Access Compliance Report

(Curb Ramps)

Intersection ID: 26103	Main Street: BEVINGTON_PL	Cross Street: COBURN_CT	Location: S
ADA ID: 32B0D6C55F5D	Ramp Type: PerpDiag	Initial Pass/Fail: Fail	Overall Compliance: No
Severity Score: 8.75			
Codes/Mitigation Info/Possible Solution		Field Measurements/Component Compliance

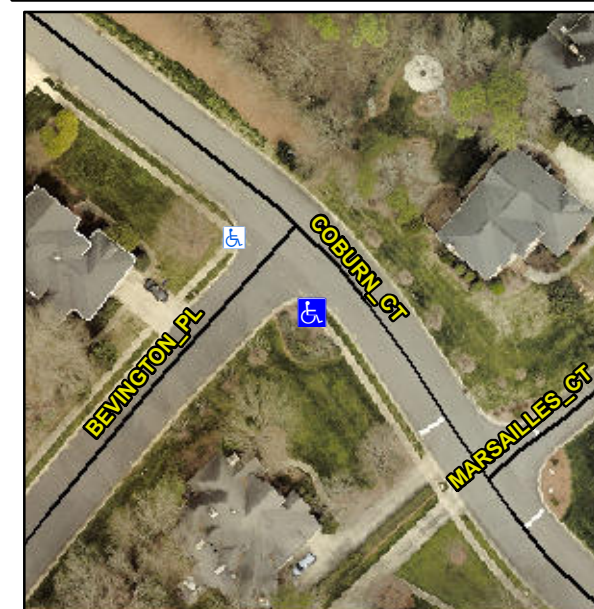
Not Found, R304.5.1

Compliance	Description	Data	Compliance	Description	Data
N/A	Ramp Length (in)	59.0	Yes	Ramp Slope (%)	5.2
No	Ramp Width (in)	44.0	Yes	Ramp XSlope (%)	0.7
N/A	Flare Type LT	N/A	N/A	Flare Type RT	N/A
N/A	Flare Slope LT (%)	N/A	N/A	Flare Slope RT (%)	N/A
N/A	Flare Traversable LT?	N/A	N/A	Flare Traversable RT?	N/A
N/A	Landing Length (in)	N/A	N/A	DWS Provided?	N/A
N/A	Landing Width (in)	N/A	N/A	DWS Contrast?	N/A
N/A	Landing Slope (%)	N/A	N/A	DWS Length (in)	N/A
N/A	Landing X Slope (%)	N/A	N/A	DWS Full Width?	N/A
N/A	Landing Curb? (Y/N)	N/A	N/A	DWS Offset (in)	N/A
N/A	Shared Landing?	N/A			
N/A	Gutter Ponding?	N/A	N/A	Gutter Slope (%)	N/A
N/A	Gutter Lip Ht (in)	N/A	N/A	Gutter X Slope (%)	N/A
N/A	Painted X Walk1?	No	N/A	Painted X Walk2?	No
	X Walk 1 Direction	To NE		X Walk 2 Direction	To NW
N/A	X Walk 1 Width (in)	N/A	N/A	X Walk 2 Width (in)	N/A
	X Walk 1 Slope (%)	4.1		X Walk 2 Slope (%)	3.9
	X Walk 1 X Slope (%)	0.9		X Walk 2 X Slope (%)	3.8

Remove & Replace Curb Ramp With Two New Directional Ramps or Equivalent.
